**SECTION 4.55(1A) MODIFICATION APPLICATION
BAYS 5-15, LOCOMOTIVE WORKSHOP, SOUTH EVELEIGH (SSD 8449)**

This application has been prepared by Ethos Urban on behalf of Mirvac Projects Pty Ltd (Mircvac), pursuant to Section 4.55(1A) of the *Environmental Planning and Assessment Act 1979* (EP&A Act) to modify Development Consent SSD 8449 which relates to Bays 5-15 of the Locomotive Workshops, South Eveleigh (the site).

The purpose of this modification request is to seek approval to dismantle and repurpose a timber and steel mezzanine platform located within Bay 15 South.

Figure 3 Proposed Demolition Plan – First Floor (SA-AR-DWG-BB-B4-0211 Rev T)

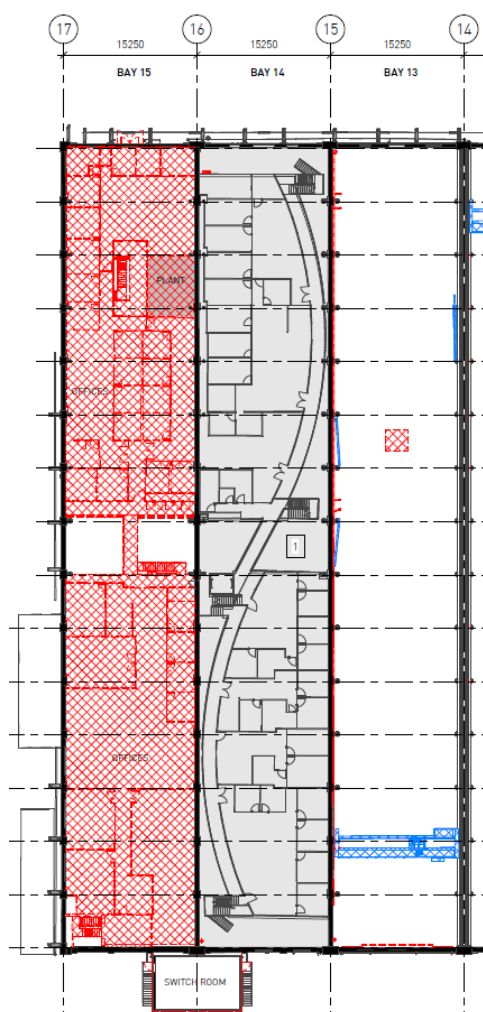
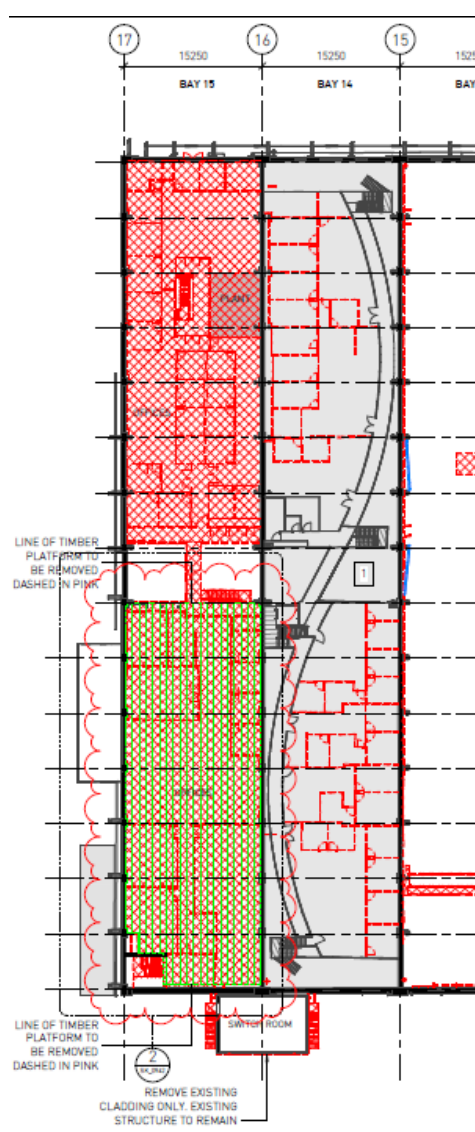
As discussed in Section 3 and illustrated in the amended demolition plans (Ref: SA-AR-DWG-BB-B4-0210 Rev T and SA-AR-DWG-BB-B4-0211 Rev T) and the additional Bay 15 demolition plans (Ref: SK_0942 Rev A and SK_0943 Rev A) included at **Attachment A, Figure 3** and **Figure 4**, the extent of the Bay 15 mezzanine platform does not go beyond the area that was originally approved to be demolished within Bay 15 South.

- dismantling the steel platform columns at Ground Floor level;
- dismantling the steel and timber mezzanine platform at First Floor level;
- dismantling of any other associated fabric.

Figure 5 Ground Floor and Level 1 Plans of Bay 15 South illustrating the extent of the mezzanine platform and location of the brick pit and adjacent brick wall

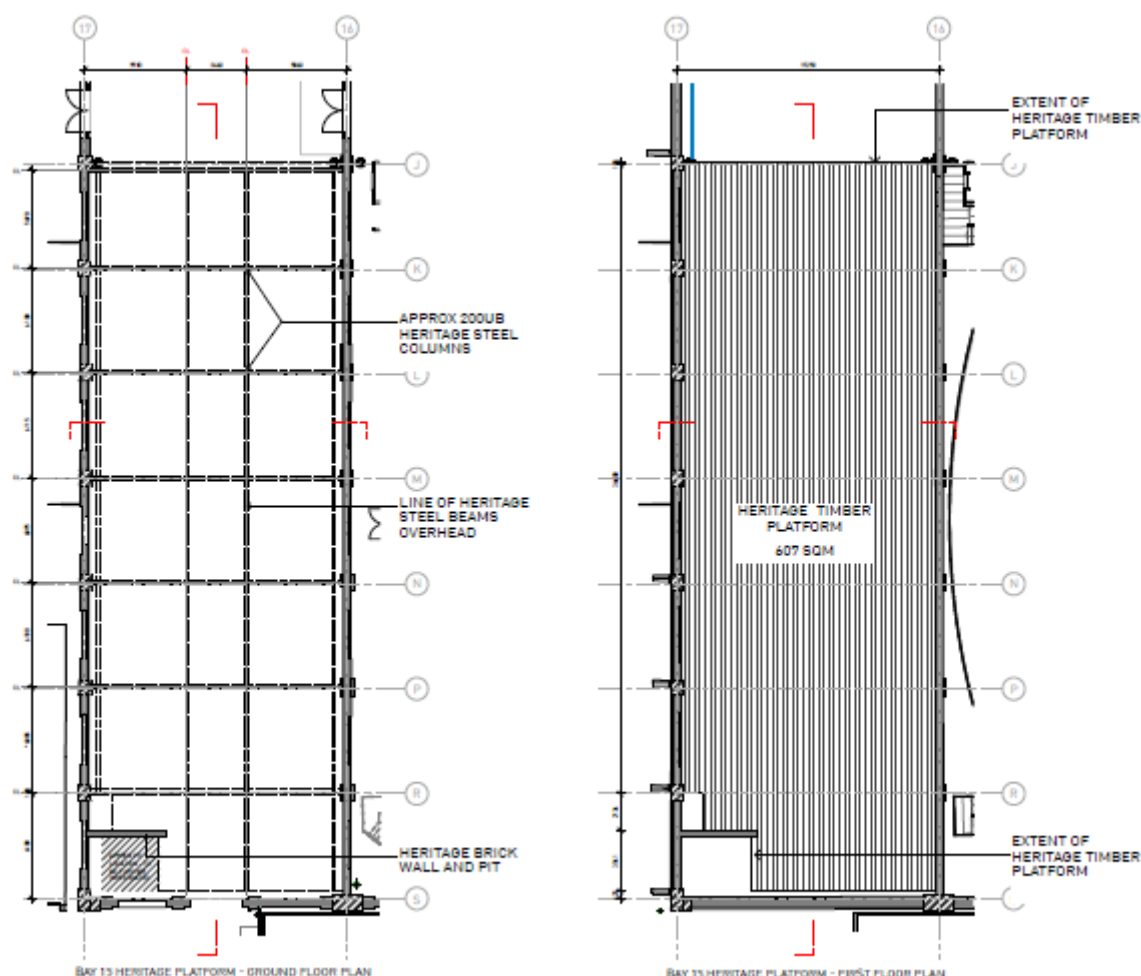
The exploratory works revealed the presence of an intact timber and steel mezzanine platform in overall good condition which spanned the southern half of Bay 15, along with a brick pit and adjacent brick wall that was located in the south west corner of the Bay, as illustrated in **Figure 5**.

Figure 6 Section plan through Bay 15 South illustrating the location of the mezzanine platform in the context of the proposed floor levels that have been approved

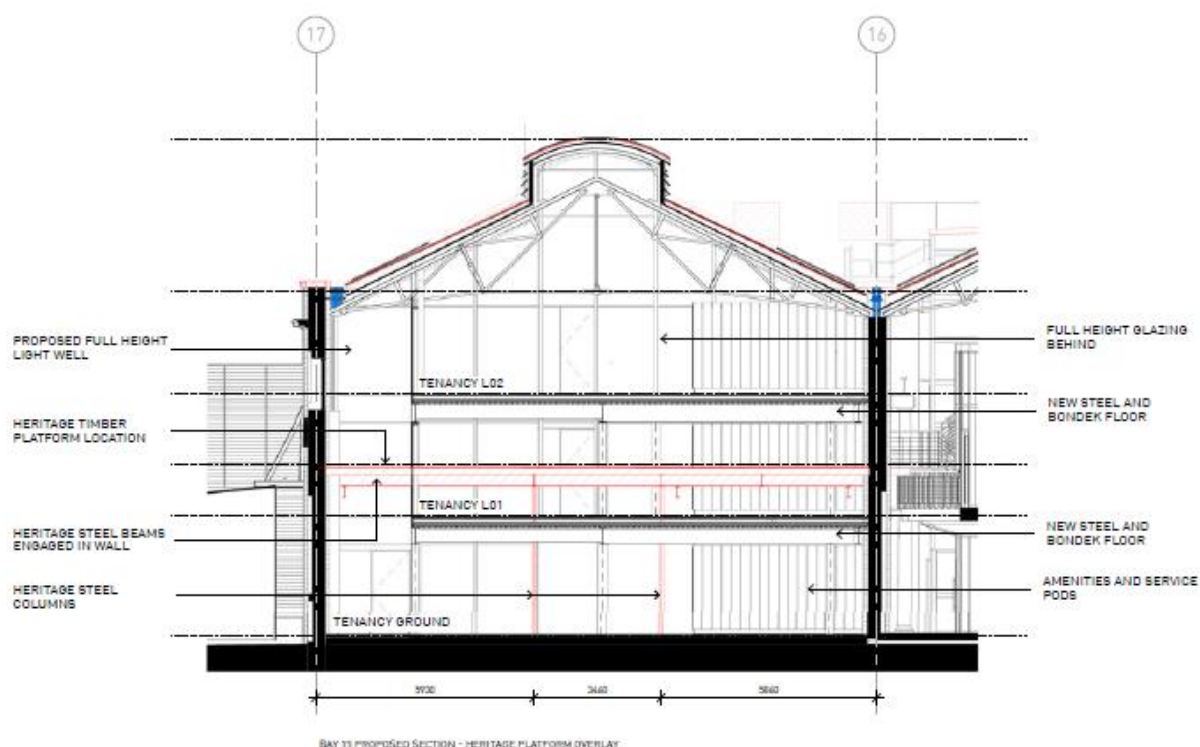
In response to finding the Bay 15 South mezzanine platform and the other associated structures, Mirvac undertook an exercise to analyse different architectural and engineering solutions in order to assess the best option in terms of viability of the project, heritage impacts and functionality for future tenants. Given the mezzanine platform was located between the proposed levels 1 and 2, as illustrated in **Figure 6**, the following four options were then assessed in terms of positives and negatives:

- Option 1 - Retain the platform in its original location
- Option 2 - Partially remove a portion of the mezzanine
- Option 3 - Relocate the mezzanine platform (raise it or lower it)
- Option 4 - Dismantle and repurpose fabric for interpretation

Accordingly, as set out clearly within the Economic Viability Analysis Report (**Attachment F**), Mirvac determined that in considering all of the potential impacts, constraints and opportunities, determined that Option 4 was its preferred and most viable option for the future of Bay 15 South.
